STAFF REPORT: JUNE 14, 2023 MEETING
APPLICATION NUMBER: 23-8518
ADDRESS: 14924 PENROD
HISTORIC DISTRICT: ROSEDALE PARK
APPLICANT: VICKI WELCH
PROPERTY OWNER: VICKI WELCH
DATE OF PROVISIONALLY COMPLETE APPLICATION: AUGUST 21, 2023
DATE OF STAFF SITE VISIT: AUGUST 30, 2023

SCOPE: REPLACE VINYL WINDOWS WITH VINYL WINDOWS

Window #7 – bedroom - 32 x 52 DH

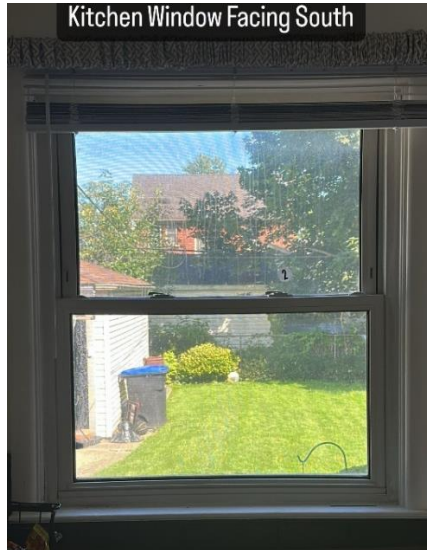
- The proposal requests to replace eight (8) vinyl windows - six (6) will remain double-hung units; two (2) double-hung windows are proposed to change to sliding units. The windows on the front and sides of the house are visible from the public right-of-way, while the rear windows are not (and one is further obscured by the screen porch).

- Staff doesn't consider the existing windows character-defining features; however, the operation and general appearance of the new replacement windows must be historically compatible with the architectural style and age of the house to be appropriate, per the NPS guidance outlined above.

- It is staff's opinion, through limits of fabrication and material, vinyl windows are not appropriate for historic districts.
 - Vinyl windows and wrapped brickmould offer a plasticity and flat/thick appearance that does not adequately match the profile/dimensionality and appearance of historic windows, such as wood.

- The installation of the proposed vinyl windows does not follow NPS guidelines for new replacement windows, as the proposed windows are not “consistent with the general characteristics of a historic window of the type and period”, are not “compatible with the overall historic character of the building”, and “similarly incompatible new windows” seek to replace “existing incompatible non-historic windows”.

Staff therefore recommends that the Commission issue a Denial for the work as proposed, as it does not meet the Secretary of the Interior's Standards for Rehabilitation, specifically Standard 9:
